CK-2279

SUMALLO RIVER 4.7km

2017 Inspection

Latitude	Longitude
49°13'49"	-121°13'57.5"
Crossing Name	Tearse Creek (structure #11)
FSR #	7510 Branch # 1
Road Name	SUMALLO RIVER
User km	4.7
Current Load Rating (tonnes)	54
Structure Class	Temporary Bridge
Portable	N
Superstructure	Steel I-beam
Deck Type	Timber - Untreated
Abutment Left	Crib, Log or Untreated Timber
Abutment Right	Crib, Log or Untreated Timber
Spans	1
Total Length (m)	14.3
Deck Width (m)	4.2

Guardrail and riser damage

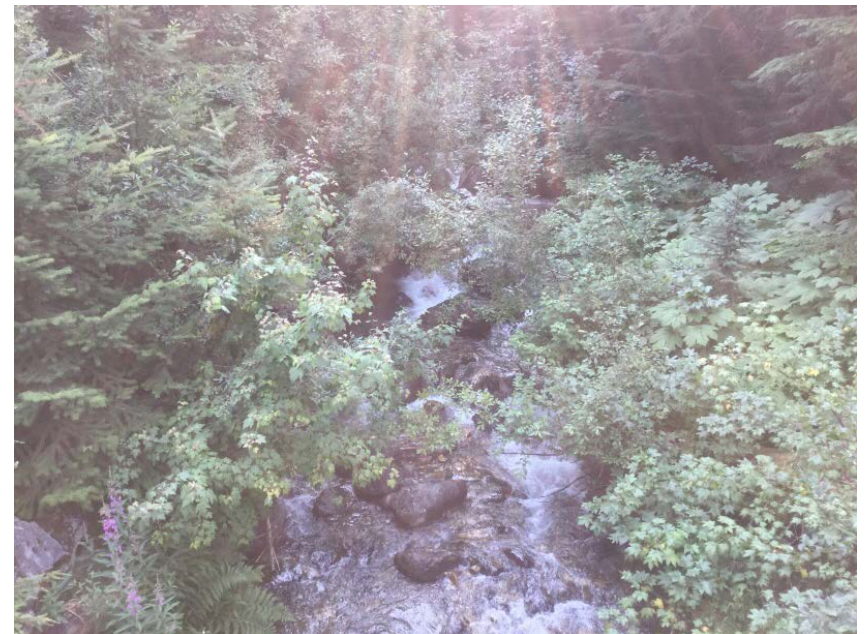
1 section of guardrail and 1 riser needs to be replaced

Guardrail bolts require tightening

Replace 3m section of guardrail and associated riser, and tighten all guardrail hardware. Place fenders at all 4 corners of the bridge and replace missing delineator. Grade and brush approaches and post bridge ahead signs when active. Present load rating of L60 or 54 tonnes to continue.

Item	Priority	Repair Description
1	Medium	Replace 3m section of guardrail, 1 riser and tighten all guardrail bolts
2	Medium	Place fender logs at all 4 corners and replace missing delineator
3	Medium	Brush and grade approaches and post bridge ahead signs
